Response to the comments

Date: Dec. 1, 2014
To: A. L. Højberg "alh@geus.dk"
From: Samy Khalaf "samykhalaf2005@yahoo.com"
Subject: Response on comments for MS No.: hess-11, C4537–C4538, 2014
"Optimal well locations using Genetic Algorithm
for Tushki Project, Western Desert, Egypt "

Fig. 1. Location map of the study area showing the location of 48 flowing wells and 9 observation wells

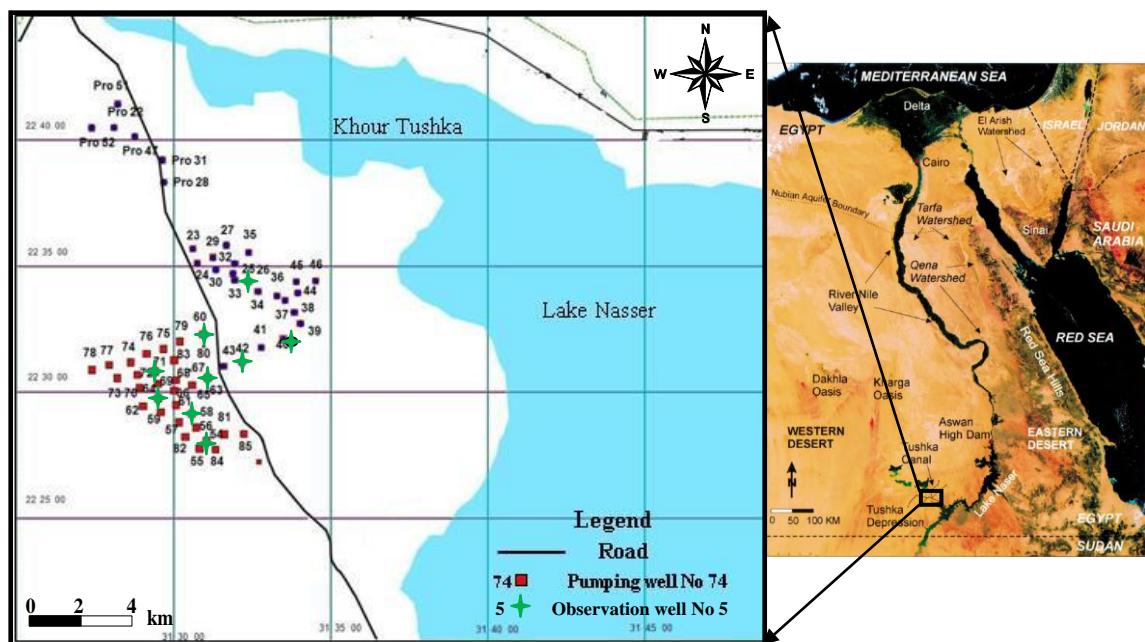
Observation data: is it only calibrated to hydraulic heads? How many observations wells? (appears to be 9 from the figures). Where are they located?

One displaying the location of the observation wells used in the calibration of the groundwater model

Different number of wells in the area is mentioned. In the site description it is stated “About 155 wells were already for this purpose (Fig. 1) besides 210 wells will be drilled by the end of the year 2017”. In figure 1 there is not 155 wells, the figure caption mentions 48 flowing wells (abstractions wells?) and in the optimisation scenarios the existing number of production wells is 68?

Reply: OK. , Number of observation wells is 9 wells and their location shown in the below figure.

Ok, the location of the observation wells used in the calibration of the groundwater model was added in Fig. (1).

Ok, sorry the different number of wells in the area is mentioned because 48 this number write wrong the right number is 68 in the figure caption "the figure caption mentions 48 flowing wells".

Fig. 5: Flow model domain grid and the boundary conditions of the NSATA model

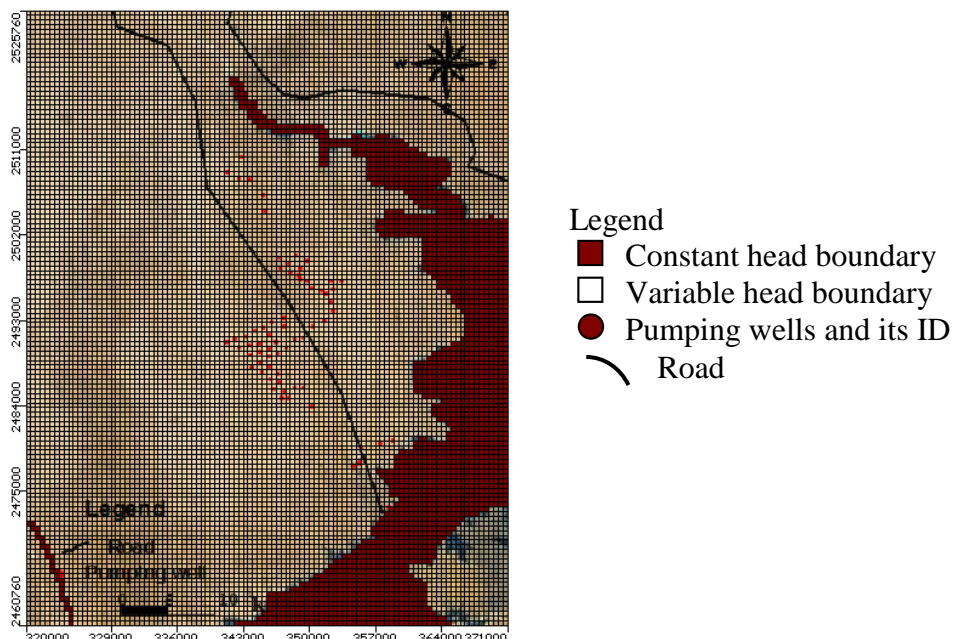
Figure 5, what is the information of this? We do not need just the discretization. It should show the different types of internal and external boundaries, where are they located and what type is used? We can only see the fixed head in the lakes, what about the others? What are the two black lines – roads? Some grids have shades from brown to blue, what is that – topography?

The information in Figure 5 are external boundary conditions (constant head the lake), grid (Δx and Δy). Black line is road (see legend) and other is grid lines. Grids have shades from brown to blue are beach of lake.

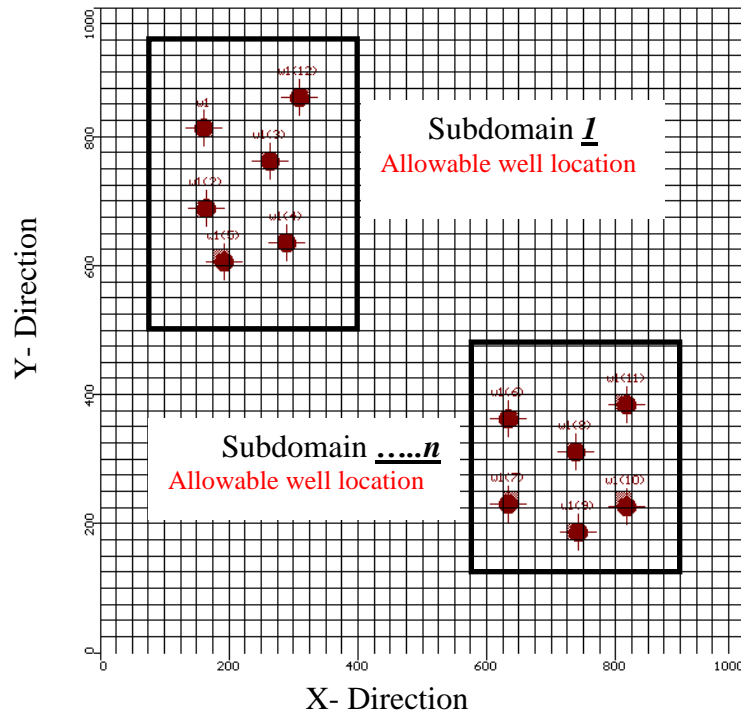
Figure 6, I do not understand this figure, what does it illustrate?

Figure 6 illustrates the constraint of location of wells; the locations of wells constraint is to be decided by the model itself within a user defined region of the model grid until the optimal location is reached..

Fig. 9: Predicted head distribution map of the NSATA for optimal pumping rates applying 1st scenario a) at 2015, b) at 2025, c) at 2035, and d) at 2060

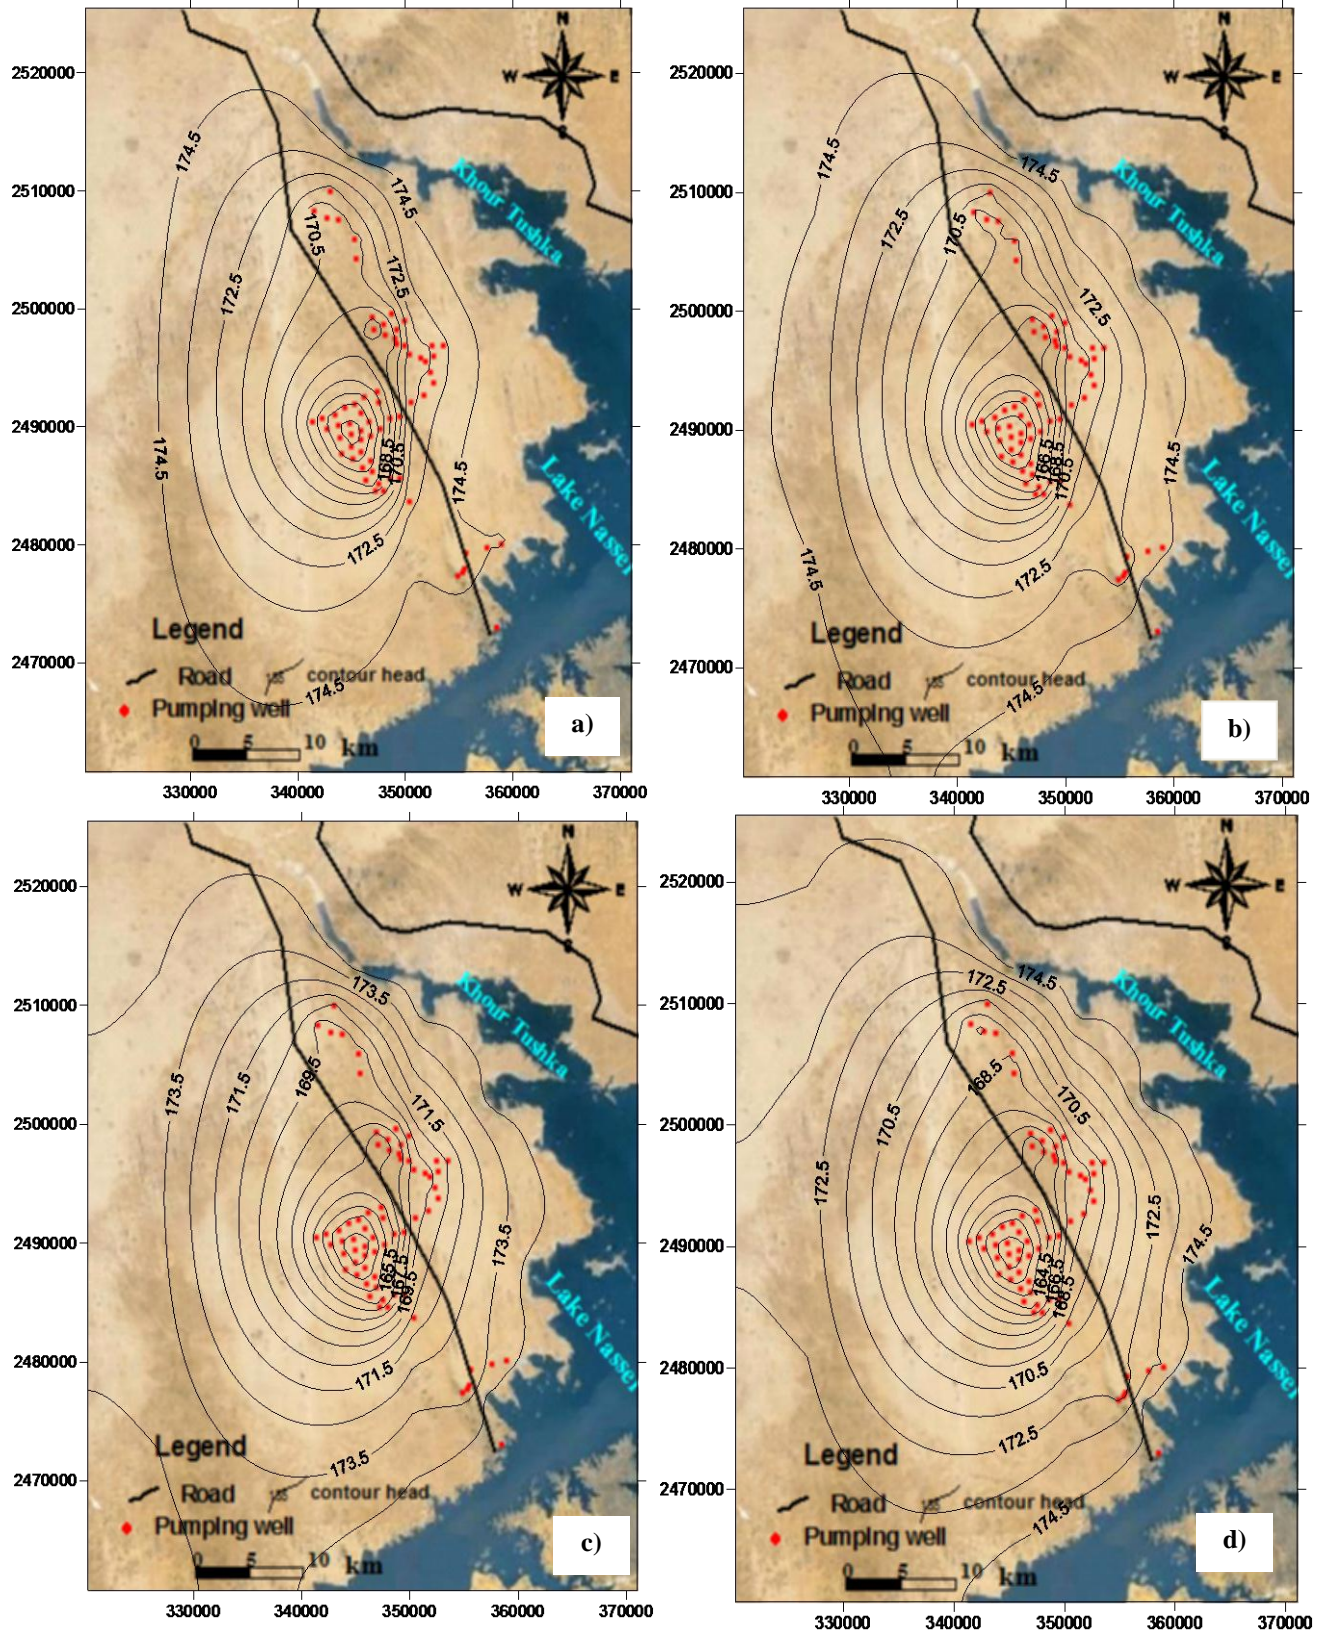
Figure 9, why is there no background for this figure displaying the results of scenario, while the results from the two other scenarios (Figure 11 and 13) have a background

Fig.10: Optimal location of wells (2nd scenario)

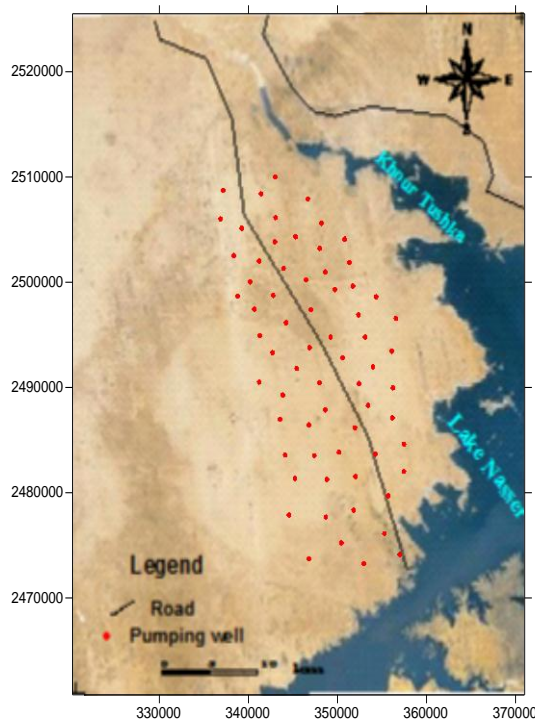
Figure 10, provides little information, either skip this figure or include the present location of the wells with another colour.

Ok, the below figure illustrate required
